## ADDENDUM 1 – JOB 47

TO: All prospective bidders on project TAU-8-984(154)157, Job No. 47 scheduled for the November 17, 2017 bid opening.

Addendum 1 is to address: Revising special provisions. Adding landscape boulders to protect path wall. Updating bridge quantities, details, notes.

Revised	11/07/17	STATE	PROJECT NO.	SECTION NO.	SHEET NO.
		ND	TAU-8-984(154)157	20	3

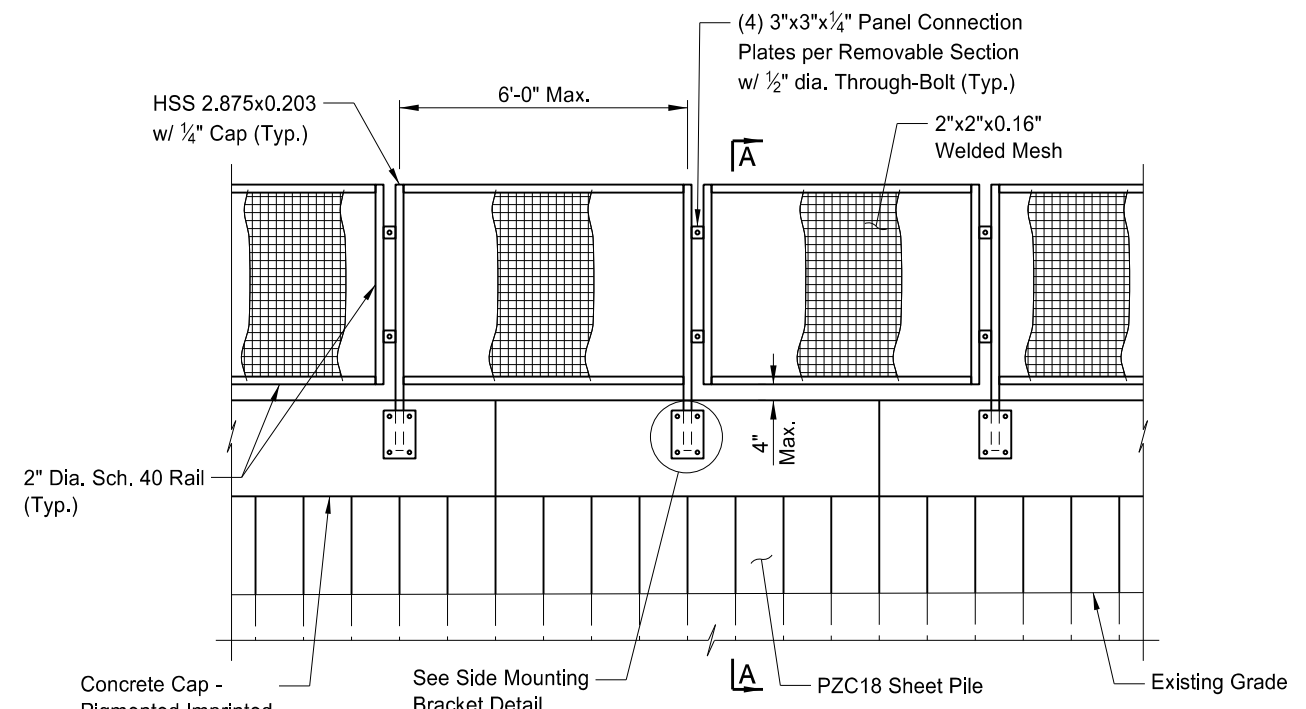
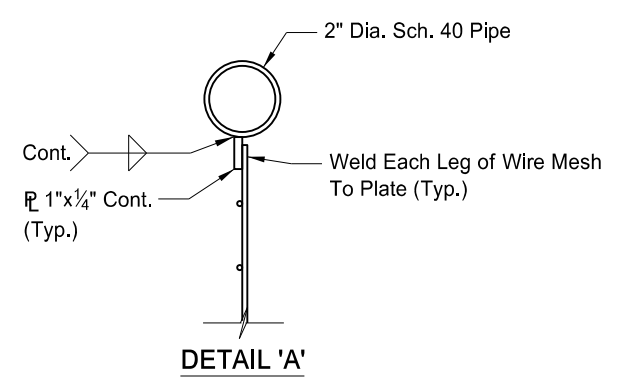
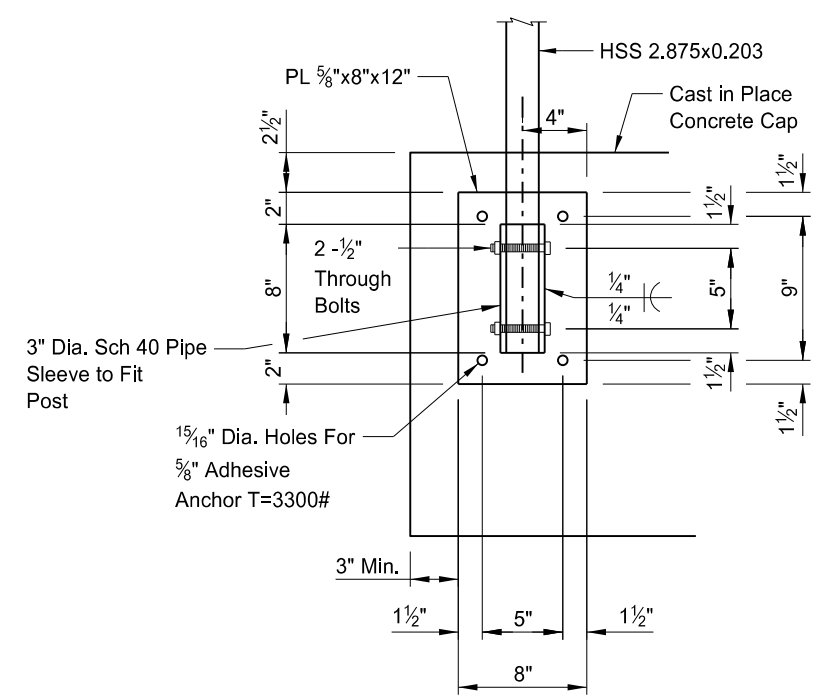
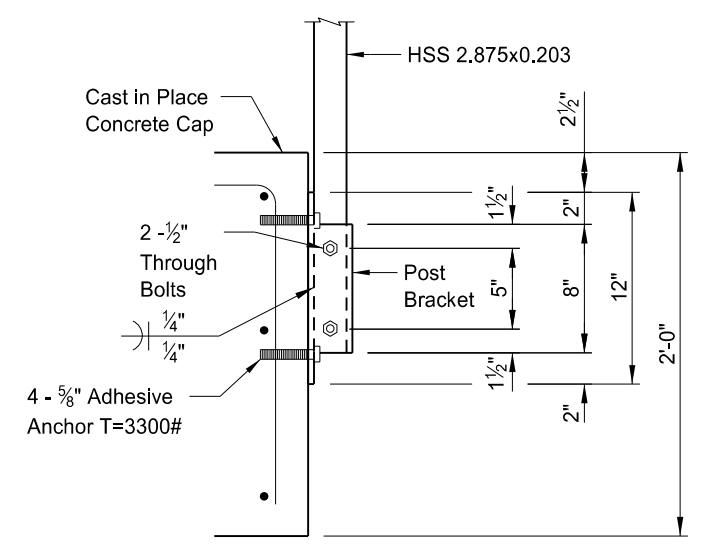
Guardrail height increased to 4'-6" and notes added.

Added	11/08/17	STATE	PROJECT NO.	SECTION NO.	SHEET NO.
		ND	TAU-8-984(154)157	20	5

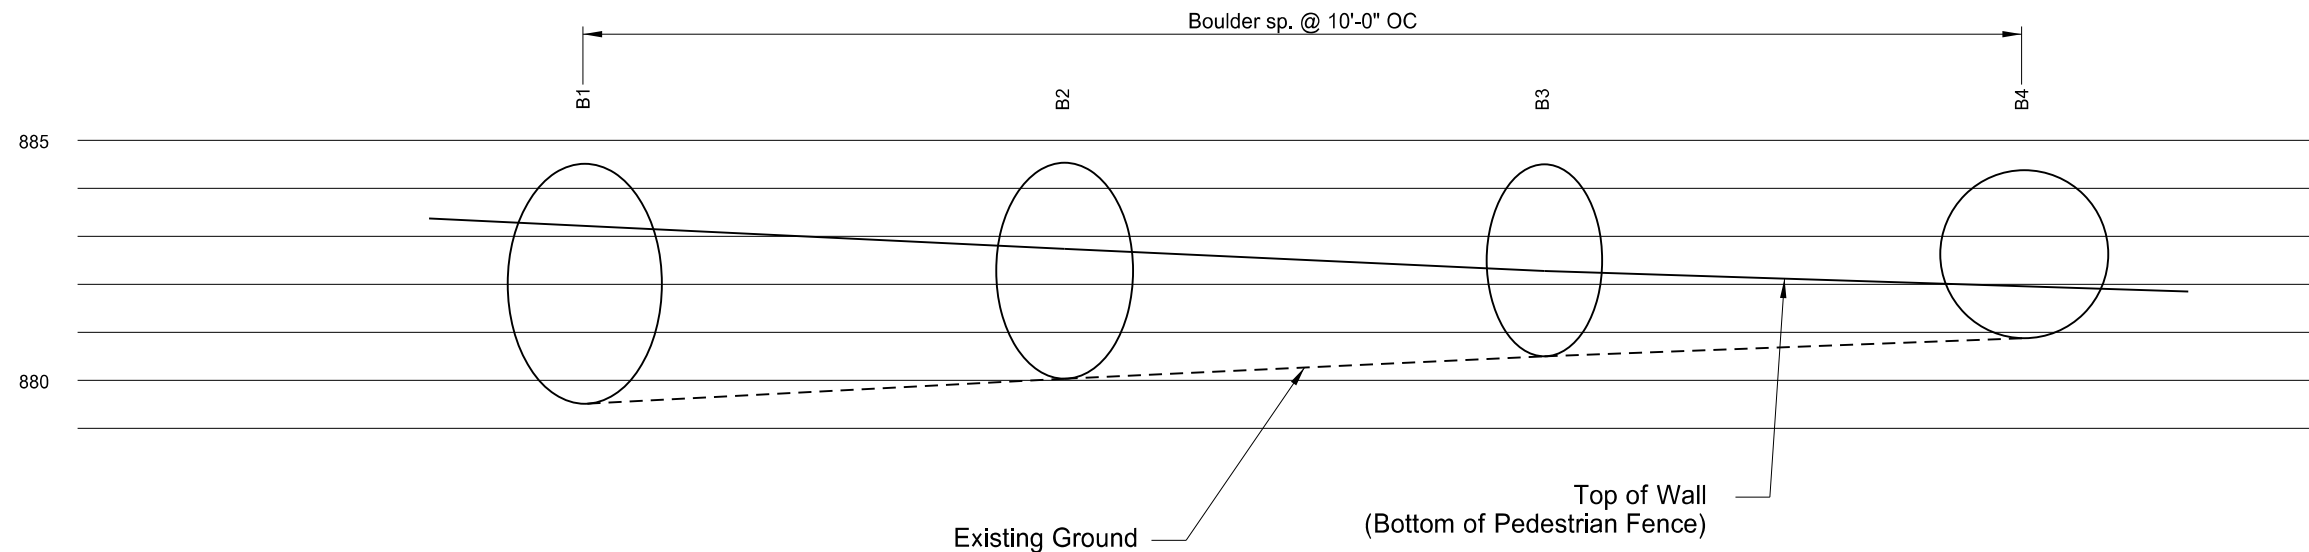
Added detail for Landscaping Appurtenances (Boulders).

Revised	11/08/17	STATE	PROJECT NO.	SECTION NO.	SHEET NO.
		ND	TAU-8-984(154)157	60	1

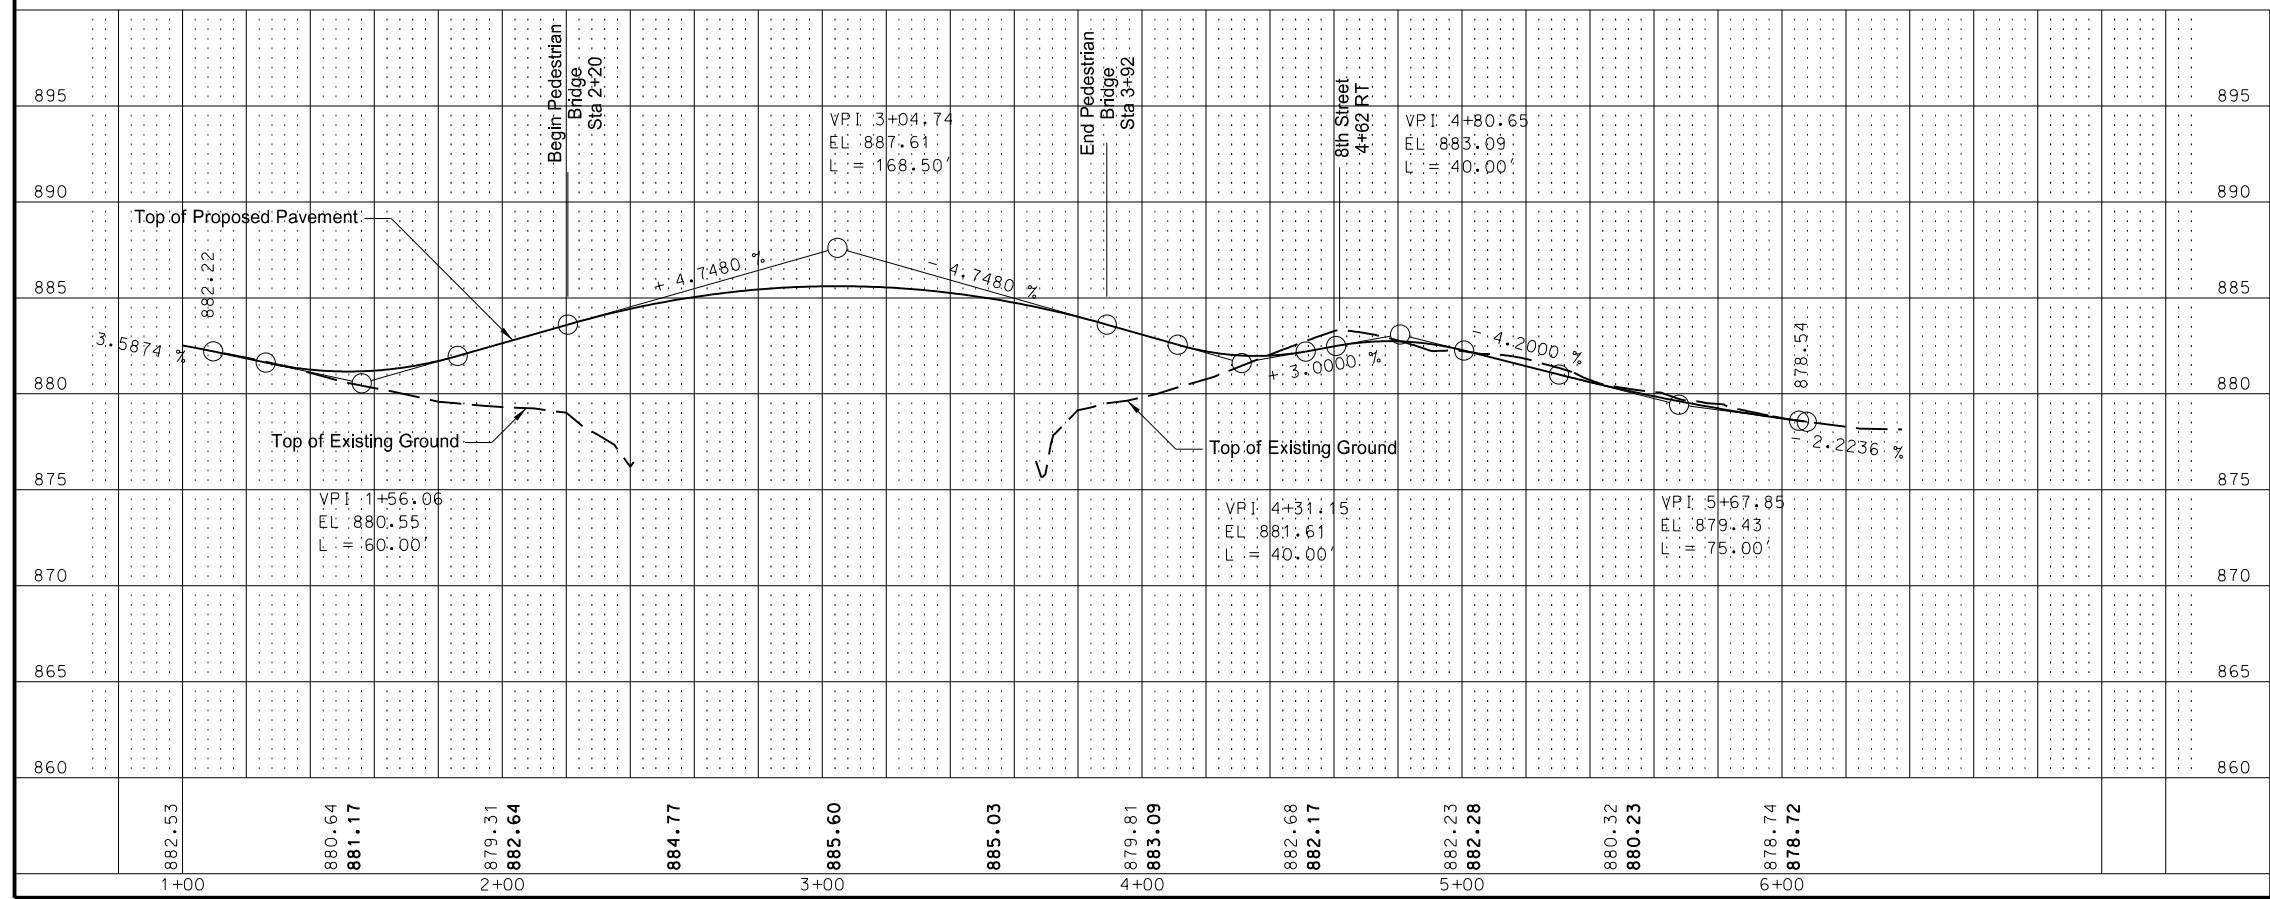
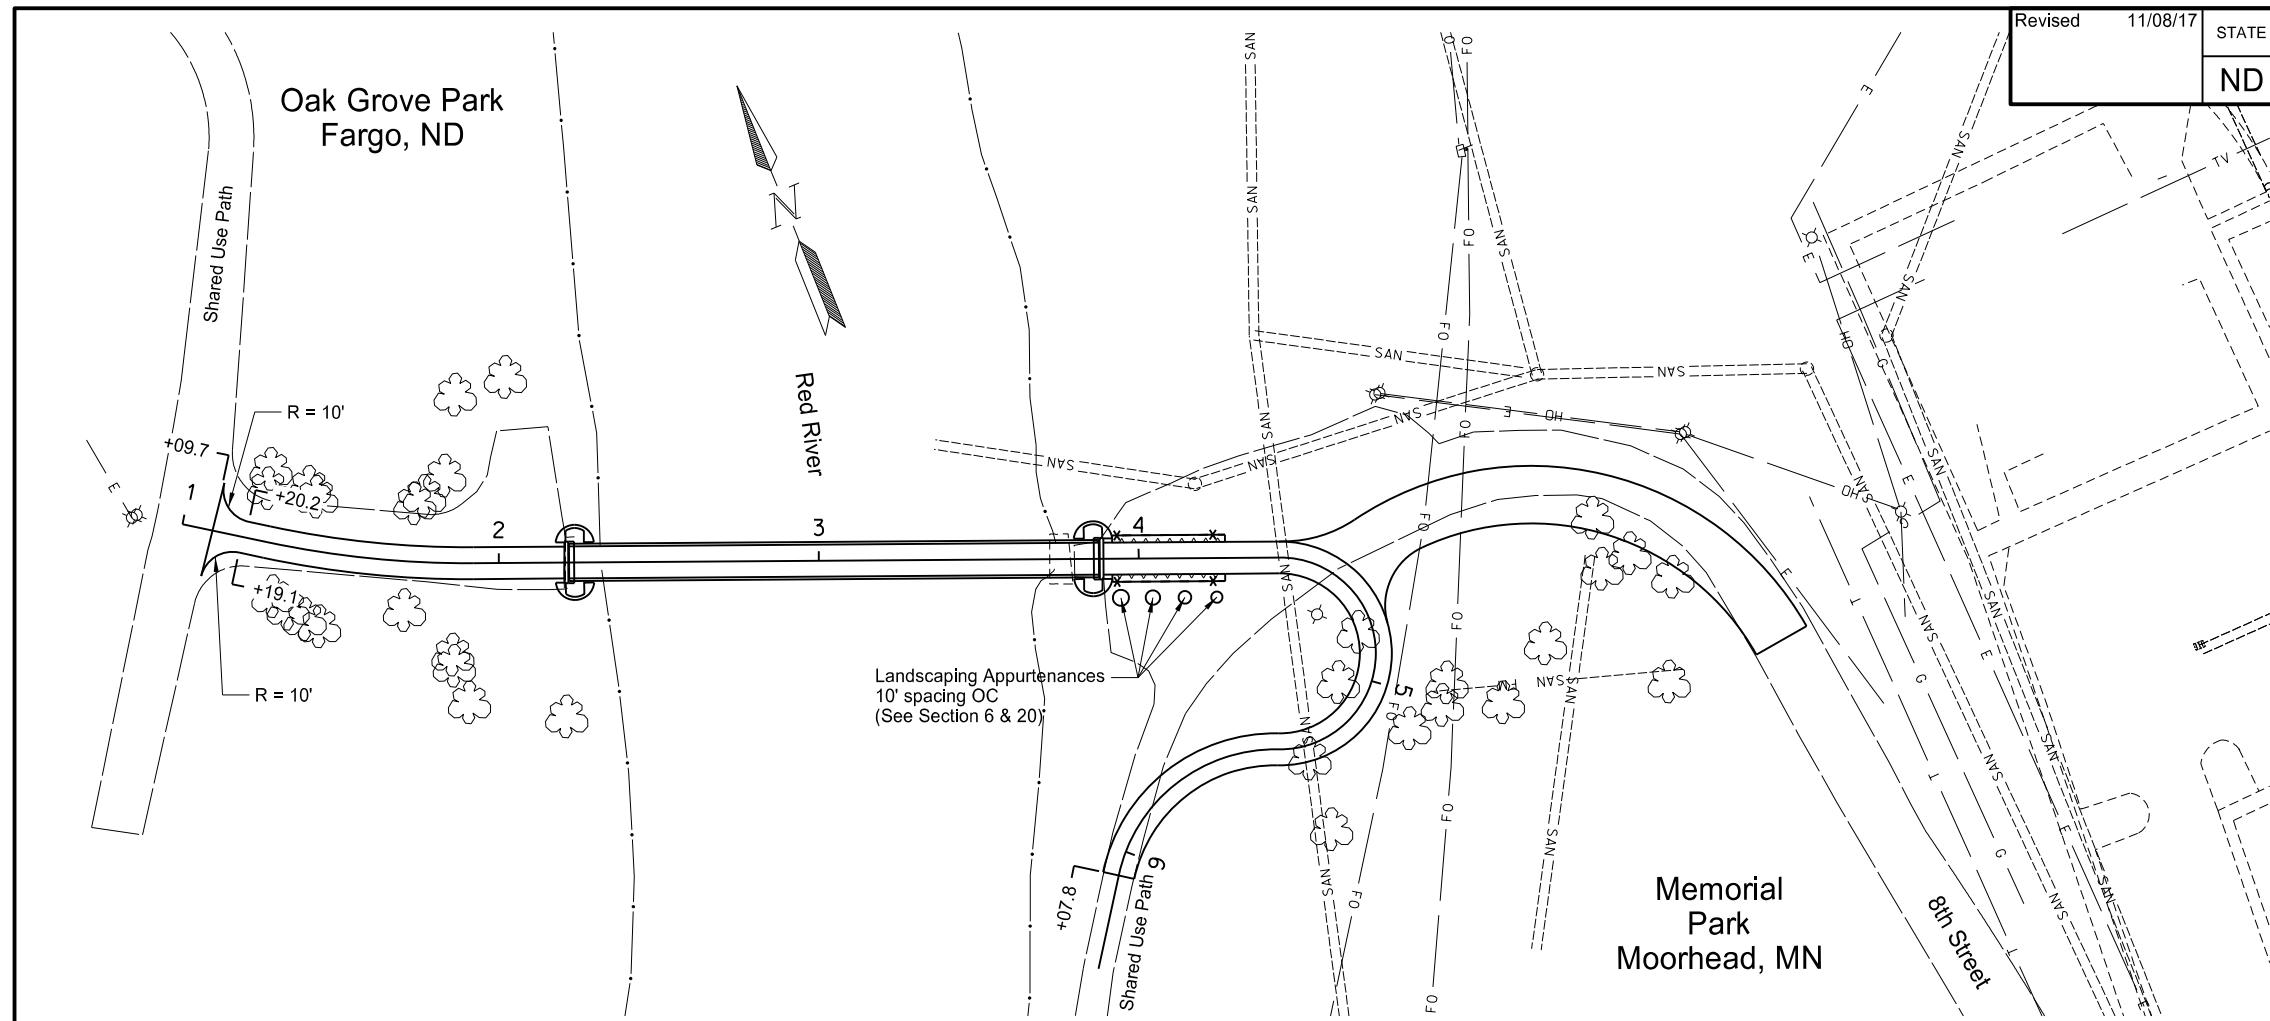
Revised to show Landscaping Appurtenances (Boulders) plan view locations.
